Denton Homes Limited

DM/23/2794 – Variation of Conditions 19 & 20 at Gatehouse Farm, Gatehouse Lane, Hassocks

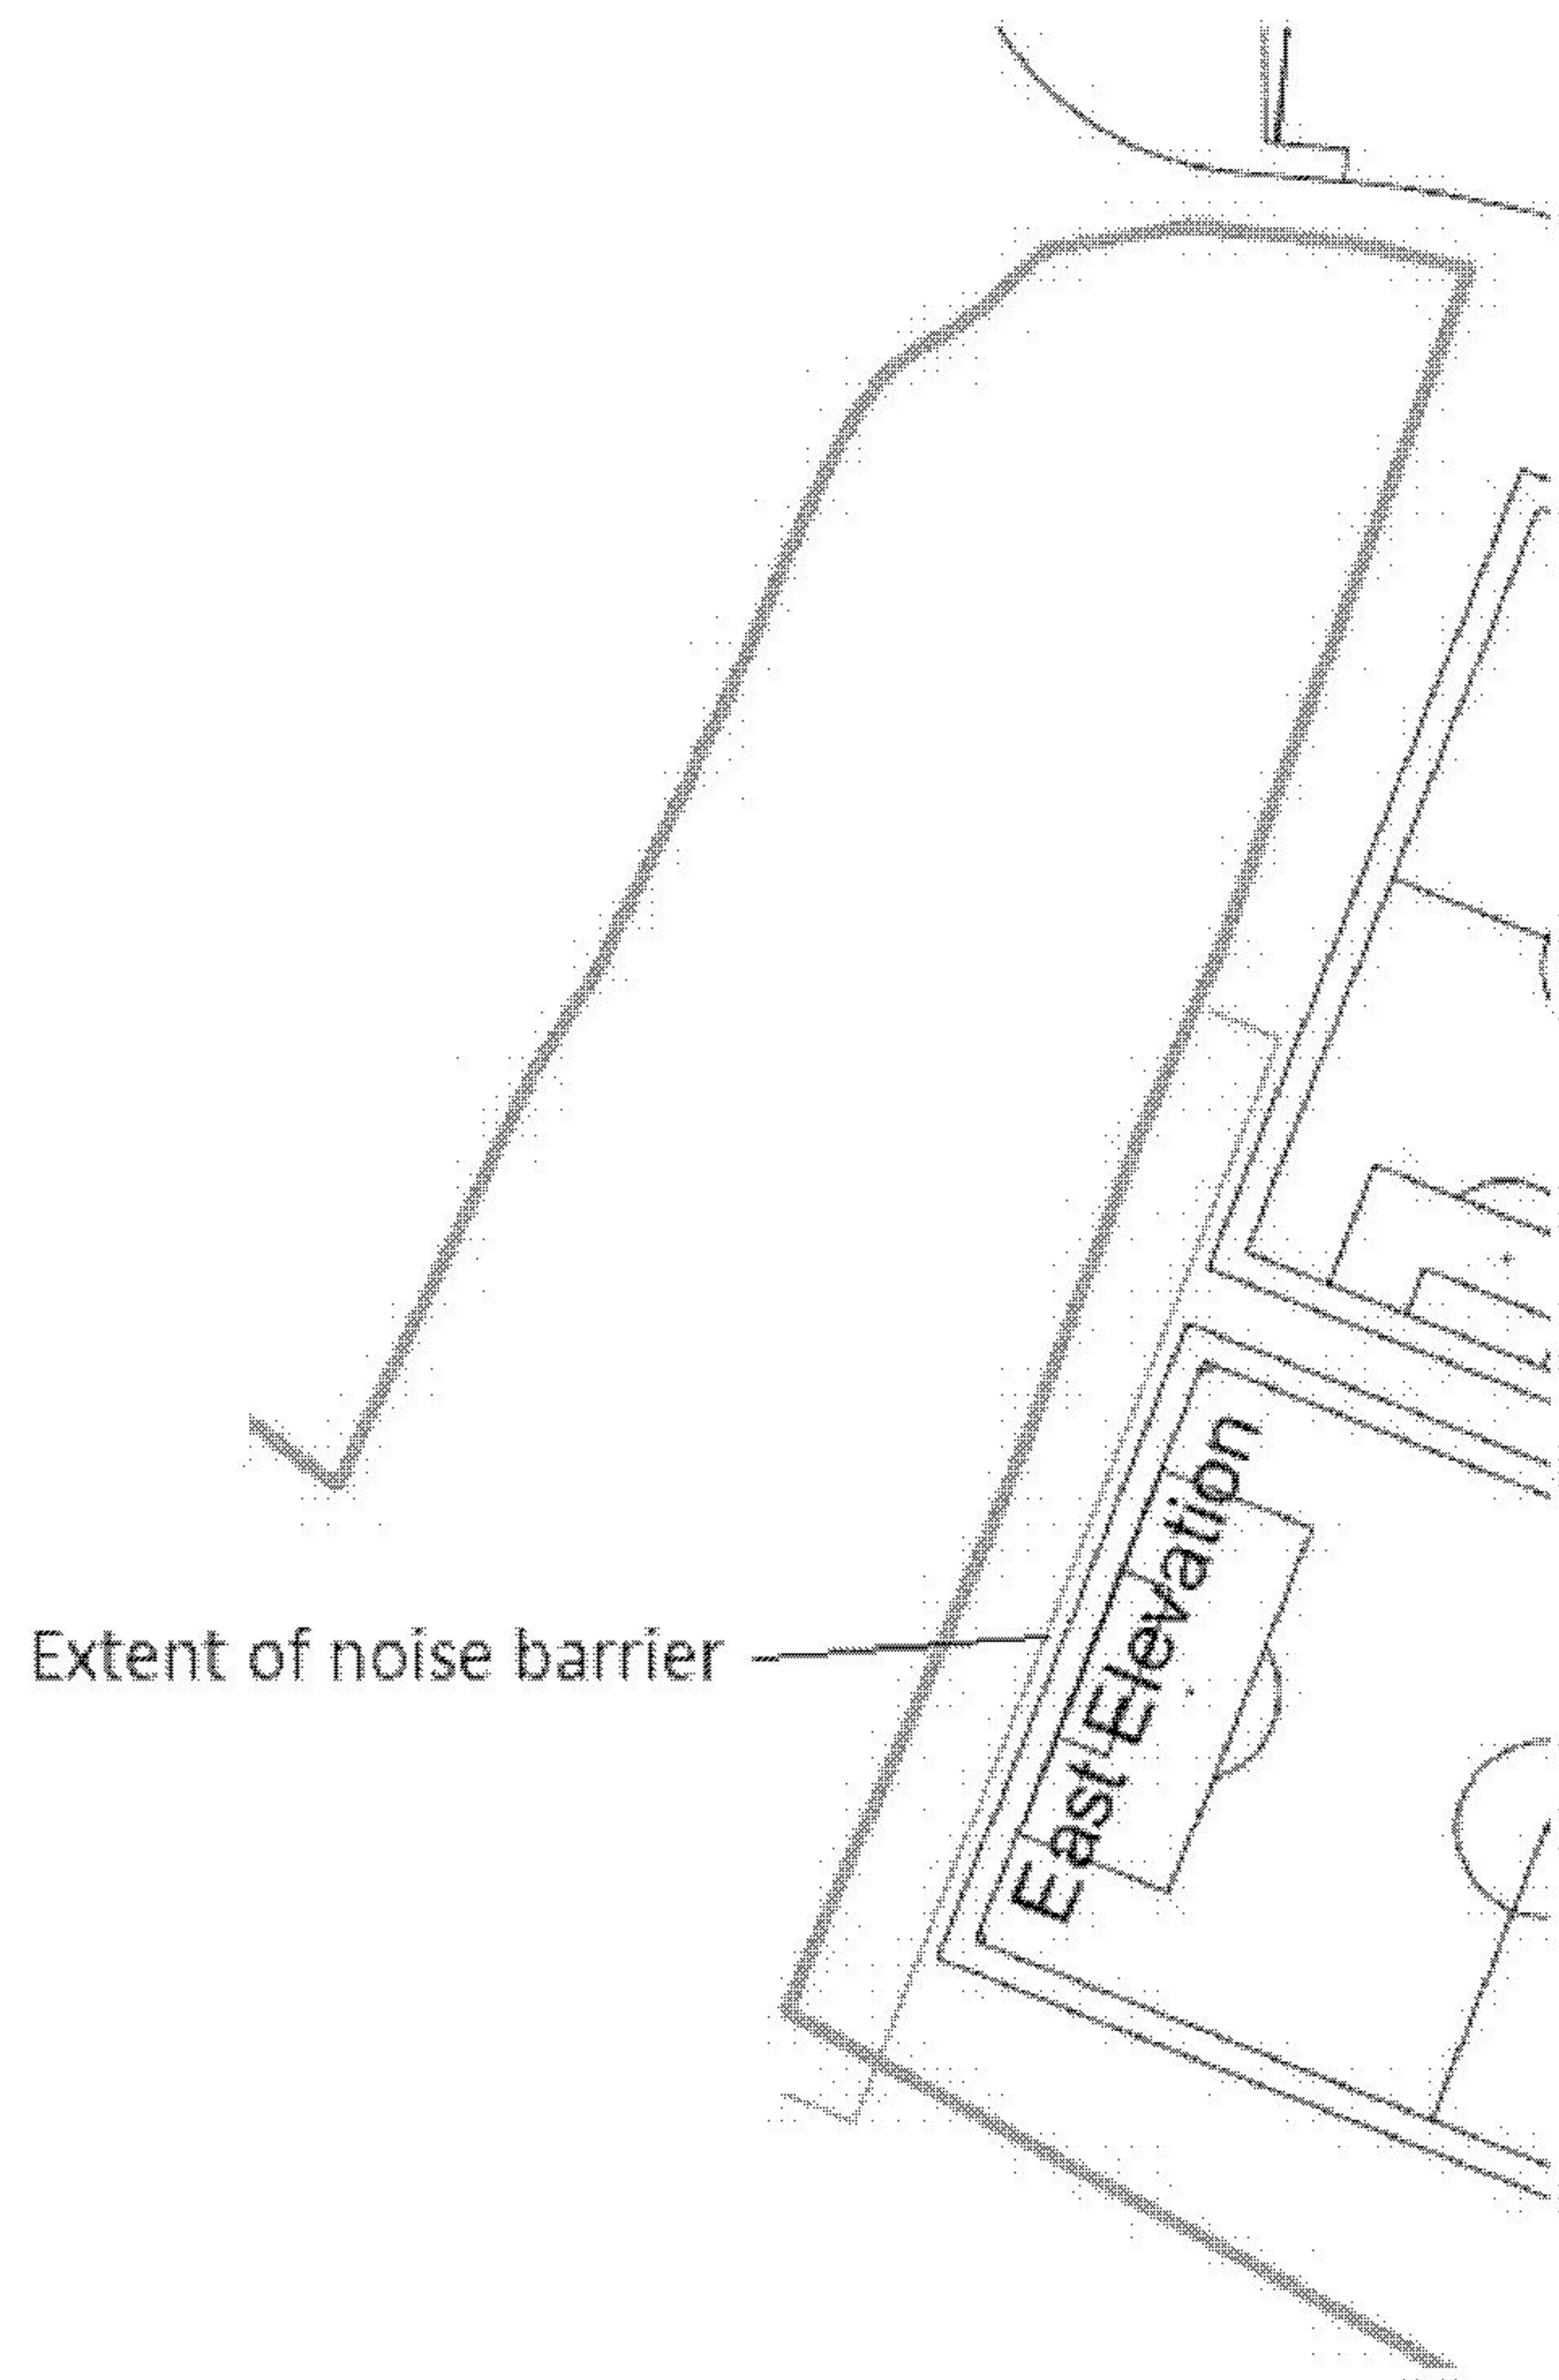
The approved scheme shows how an acoustic fence would be added to the eastern boundary and part of the northern boundary at a height of 2.5m. The extent of the acoustic fencing is shown below in purple:

The current application proposes that the acoustic fence on the eastern boundary of the Gatehouse Farm Site be removed where it is directly behind an identical acoustic barrier within the Centre for Outdoor Sports.

A more conventional close boarded fence of some 1.8m in height would be installed on the boundary as an alternative to the approved acoustic fence.

20. Prior to the occupation of any dwelling the acoustic fencing hereby approved to the northern and eastern boundary as shown on drawings ~~004 RevP6, 005 RevP5 and 015 RevP1~~ 015 Rev P3 shall be installed and thereafter be retained.

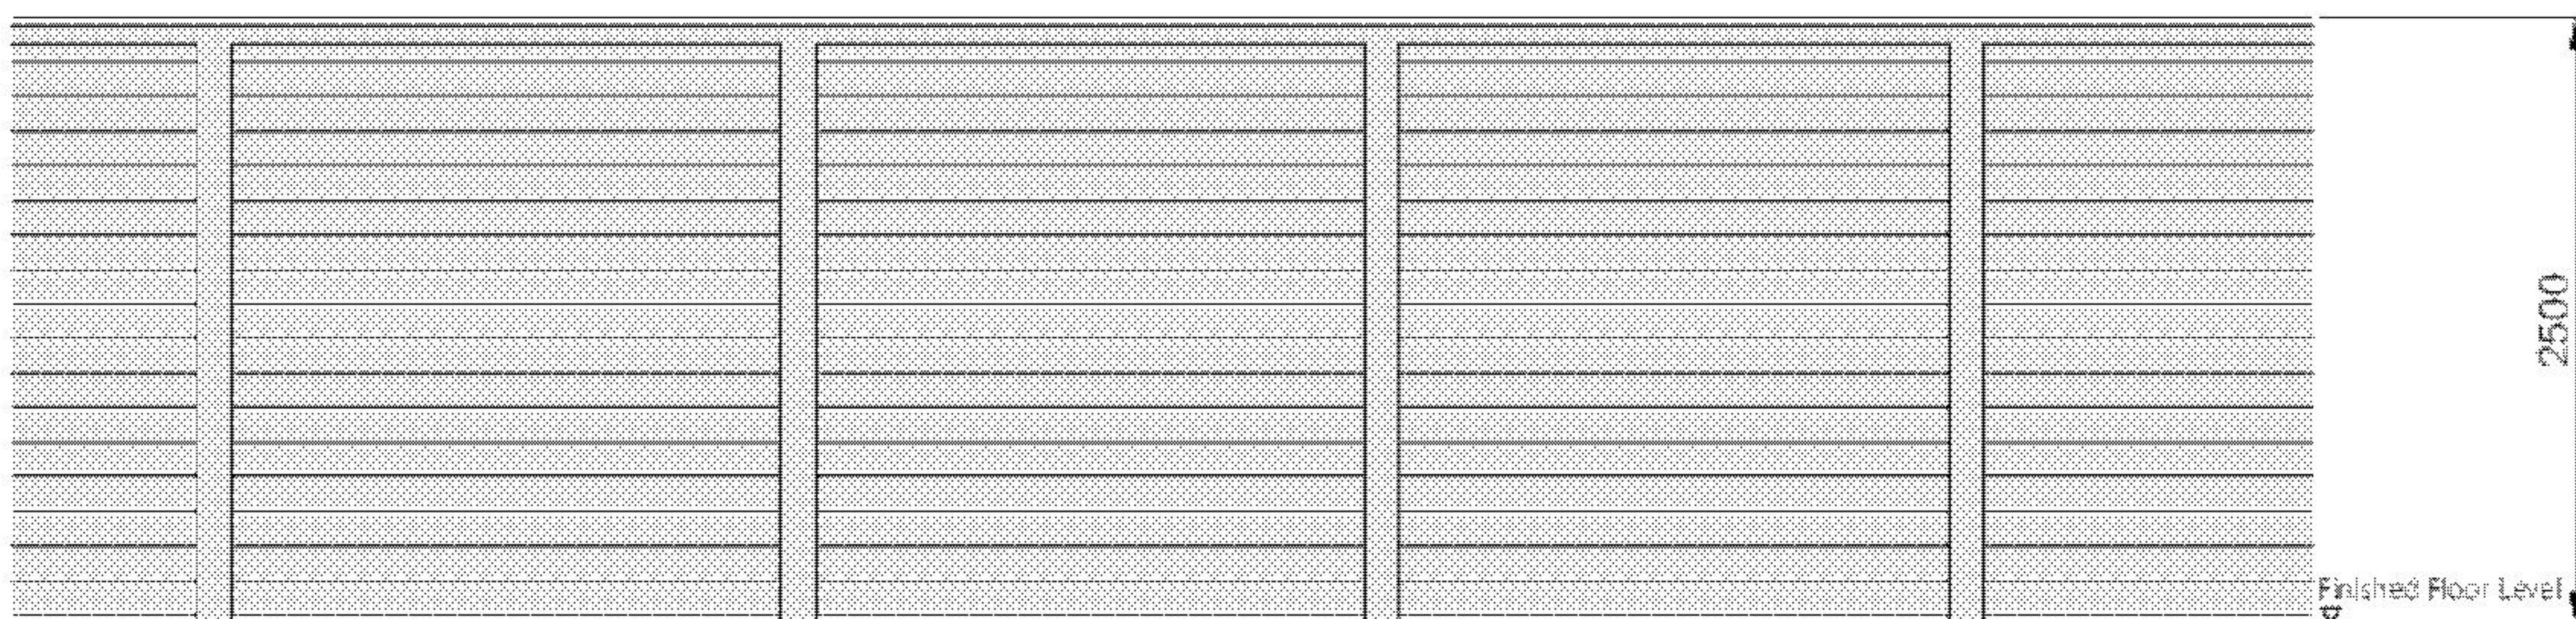
At the same time, a noise barrier of the same height and specification would be inset around 1m from the eastern boundary within the adjoining "Centre for Outdoor Sports" development. It would extend for circa 96m, with the extent of the noise barrier in that case indicated in red below:
